ENVIRONMENTAL
♦ COUNCIL ♦
OF SACRAMENTO

SUBJECT: Comments on the Draft Supplemental Environmental Impact (DSEIR)
SACRAMENTO COUNTY WATTEV INNOVATIVE FREIGHT TERMINAL
(SWIFT) PROJECT, Control Number: PLER2023-00069

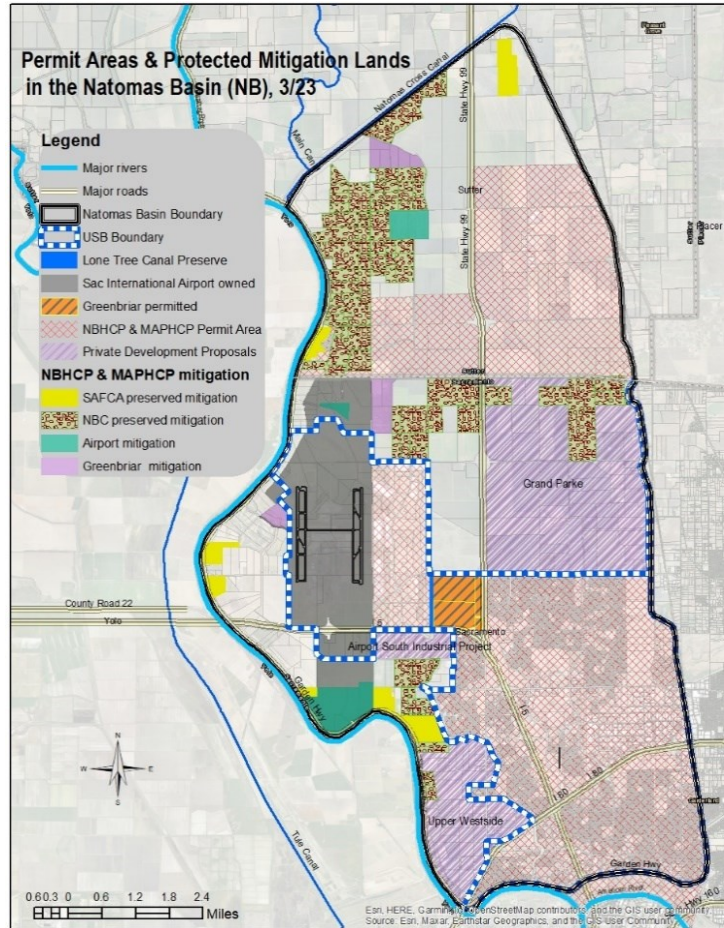
6. The EIR fails to acknowledge the proximity of permanently protected mitigation land to the project site and does not evaluate the impact of the solar array and increased human presence on the protected Natomas Basin Conservancy lands and mitigation properties belonging to SAFCA and Sacramento County Department of Airports. The map at right (prepared by Habitat 2020 volunteers) shows the Permit Areas and the protected lands and landowner proposed developments outside the City and Sutter Permit Areas. The map was prepared before ECOS and Habitat 2020 were aware of the Watt EV project, so it is not designated as such on the map.
